Corrigendum/ Addendum

Tender Ref no.- 24/RT/Cath Lab/Neuro Surg/793/2026- Rish (Admn)

Tender Subject- Tender for procurement of Biplane Cath Lab for Department of Neuro Surgery, AIIMS Rishikesh

Annexure E4a

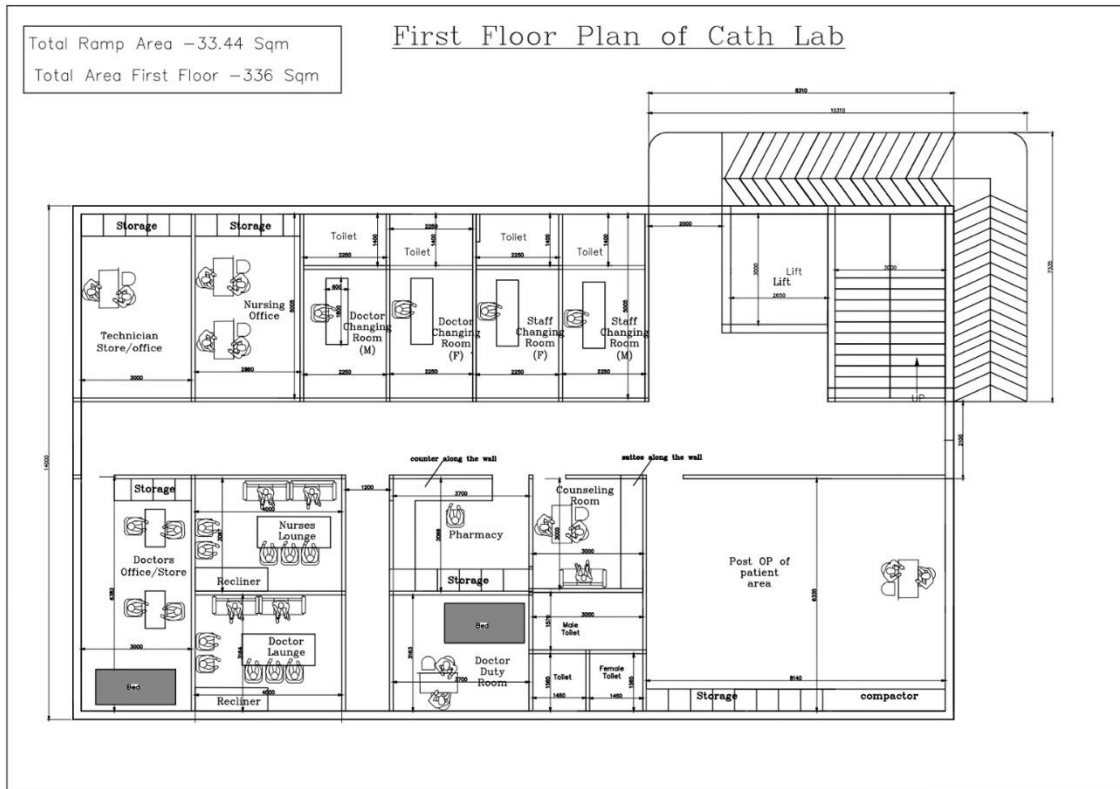
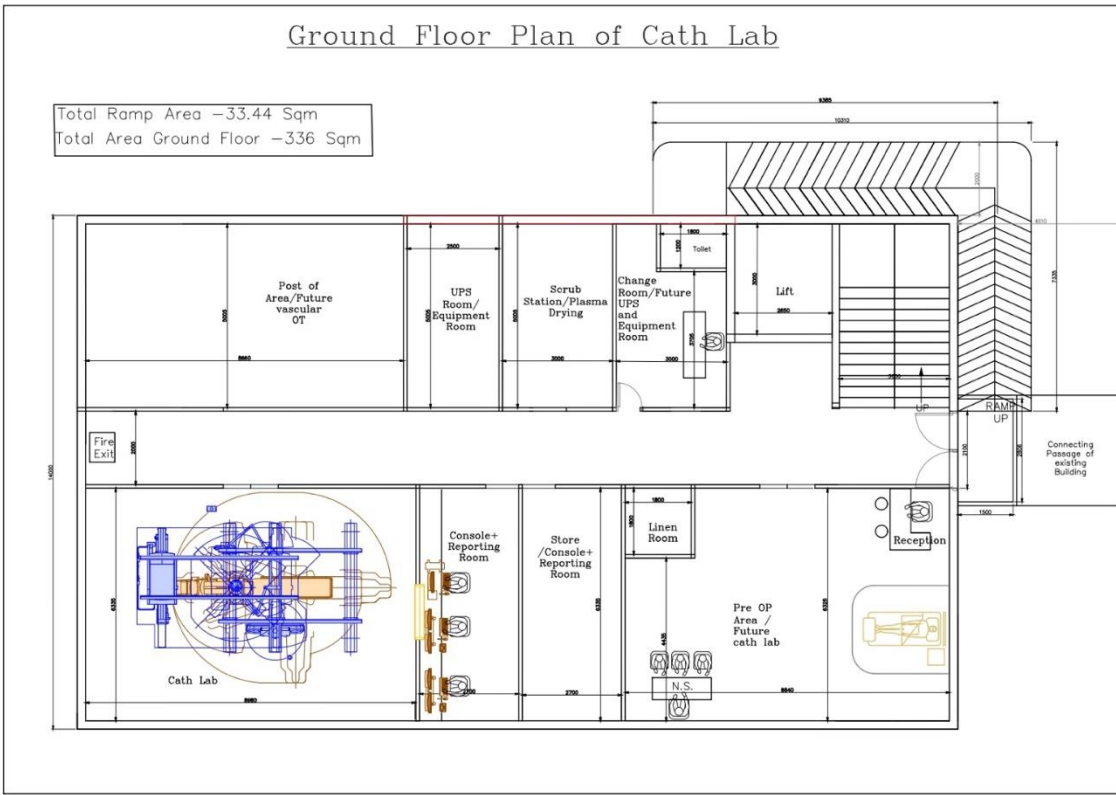
Other furniture items as per requirement of rest of areas (like table and chair for reception counters/ patient ward nurses counter etc.) calculated as minimum 13 tables, 45 chairs, 5 +1 settees, 4 three seater sofas, 2 beds, 2 recliners, counter in pharmacy and reception area, storage racks and compactors for files of different sizes, attached as Annexure- E4a and Annexure E4b. (These are in addition to items mentioned in points 1, 2 & 8 in same heading)
